To: FCC OET Laboratory, ATTN Steve Martin

From: CURRENT Technologies

Regarding: Correspondence 31235, FCC ID TY7210-0150, EA296140

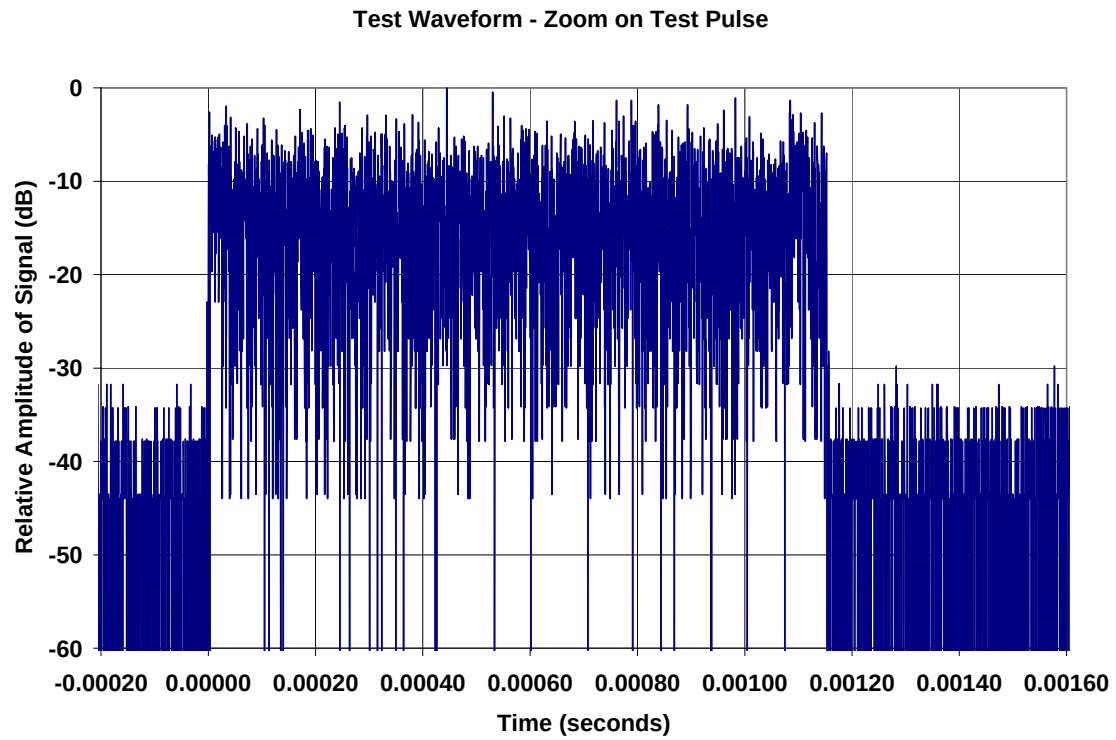
Q: Submitted installation manual does not include any operator instructions related to complying with FCC interference mitigation and avoidance requirements. Please provide sections of operator instruction manual for this EUT or for the system controller relevant to compliance with these requirements. (E.g., achieving the notch depth requirements in 15.611(c) may require masking out several carriers beyond the edge of the band to be protected. How is this information conveyed to the operator?)

A: An operator document describing the notch conditions is attached to this correspondence reply.

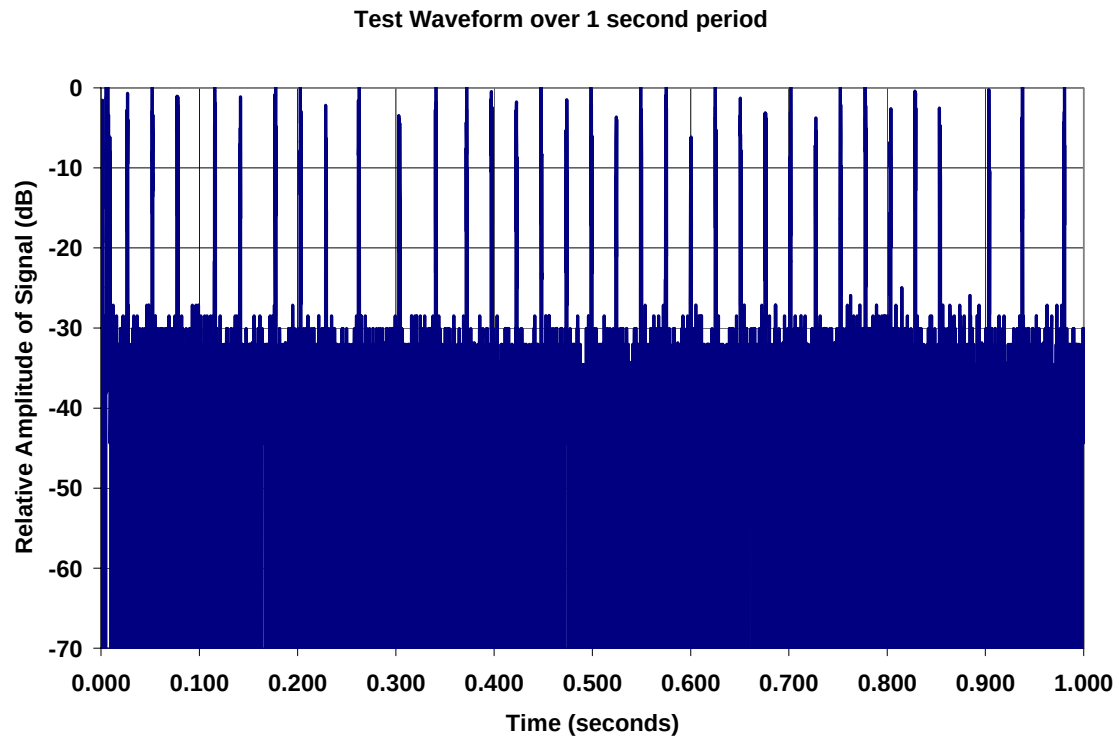
Q: What was the burst rate of BPL signal injection onto the power lines during testing for each band of operation?

Q: Please specify the maximum RF injection duty factor achievable by the device and identify the duty factor of signal injection during testing for both bands of operation.

A (To both questions directly above): To generate test traffic on both medium voltage and low voltage, a special mode in the device was used that forces the BPL modem to continuously generate transmission on the line. This works by forcing the modem under test to repeatedly and continuously transmit system overhead messages. The ‘*mfgviperon*’ command transmits these in a manner that exceeds the normal ability of the modem to generate traffic in actual use, by repeatedly sending these overhead messages to a remote station on the powerline. These messages generate 200 OFDM symbols over 40 times per second, ensuring that the 20 pulse per second minimum is exceeded, and that the transmit rate approaches the maximum achievable with these signals in actual operation. As the maximum duty cycle in a CSMA network such as this is indeterminate; this technique ensures that a repeatable measurement can be conducted while ensuring that the quasi-peak detection filter is not allowed to decay, and reduce the measured level in a manner not indicative of its maximum transmission.

To illustrate this point, the signal was generated in a laboratory and its time domain waveform captured. This data is shown below. The figure below shows a plot of the 200 OFDM symbol burst.

Note that the burst is longer than 1 ms, ensuring that the signal remains continuously on during the rise time of quasi-peak detection filter.
